**Re: Aurora One PA 4 (#1610131)/Pre-Application Meeting held March 10, 2022**

**Application Number: DA 2241-004**

**Case Number: Pre-App #1610131**

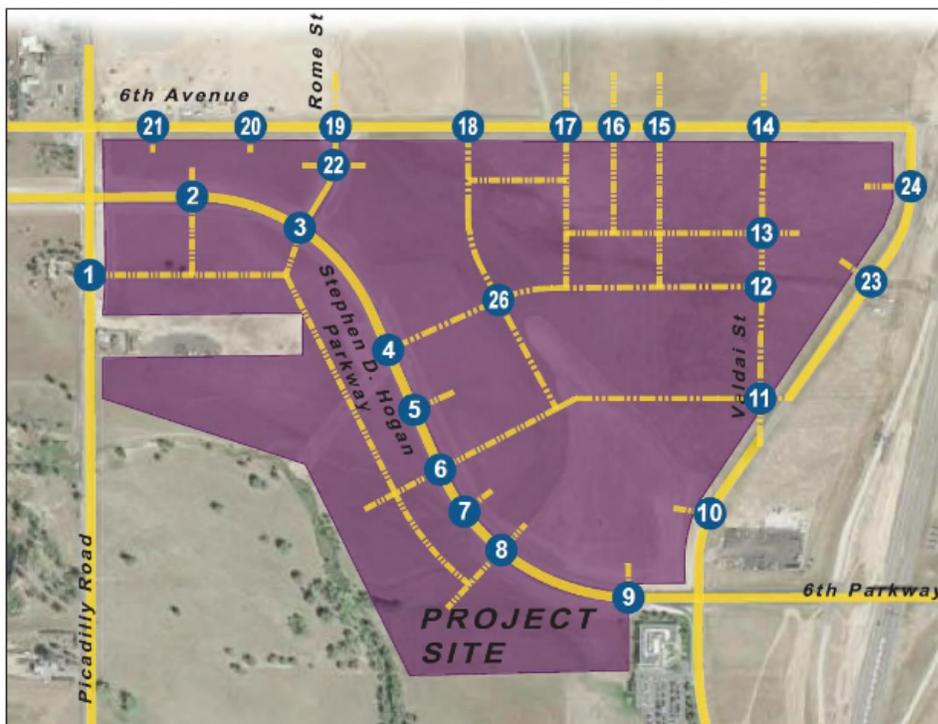
The figure below is derived from the Traffic Impact Study and illustrates the proposed and studied street network for Aurora One. As you can see, a network which complies with the block length and perimeter standards of the UDO is identified. The expectation is that this street network will be used for Planning Area A, as it provides connectivity within and to other portions of Aurora One. A major street connection, which is located to the west of the planned detention pond, shall be constructed concurrent with the development of Planning Area 4. This 80-foot two-lane collector street section is illustrated in the PIP. *Noted. Proposed street network matches Master Plan except the removal of the road north of the Park/Pond.*
